UNITED STATES
DEPARTMENT OF THE INTERIOR
BUREAU OF LAND MANAGEMENTFORM APPROVED
OMB NO. 1004-0137
Expires: January 31, 2018**SUNDRY NOTICES AND REPORTS ON WELLS**
*Do not use this form for proposals to drill or to re-enter an abandoned well. Use form 3160-3 (APD) for such proposals.***SUBMIT IN TRIPLICATE - Other instructions on page 2**

CHEVRON U.S.A. INC respectfully requests official approval for the P&A of the 5.5" liner and temporarily abandonment of the rest of the wellbore in the subject well, to allow Chevron the option for future operations within the TA'd wellbore. Per the attached email, we proceeded with operations over the weekend to execute the approved plan per Chris Walls, BLM. We swabbed out the fluid in the well to gelled FW and set the first plug from 17,192' to 16,865', confirmed by tagging, to isolate the open hole above the fish. The second plug from 15,505' to 15,005' covered the Morrow formation at 15,440'. The third plug from 14,738' to 14,294' covered the 7 5/8" shoe at 14,680' and the 5.5" liner top at 14,433', and was confirmed by tagging. A final forth plug was set from 14,004' to 13,430', per Chevron Barrier SOP to have 2 plugs above a liner top, and

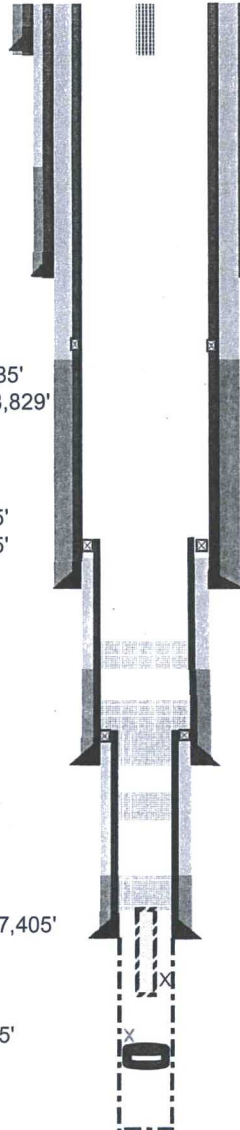
Submit a sundry to plug the well back and request shut in status for the well (include time period) with the following changes.

1. 1st plug is okay
2. add plug from 15500-15200'. No tag required. (Morrow top 15440')
3. Change the top plug interval to be from 14730-14383' tag.

You have approval to pump these 3 plugs with the modifications I have made. Contact the HFO at 575-393-3612 and coordinate the rest of the Job with them.
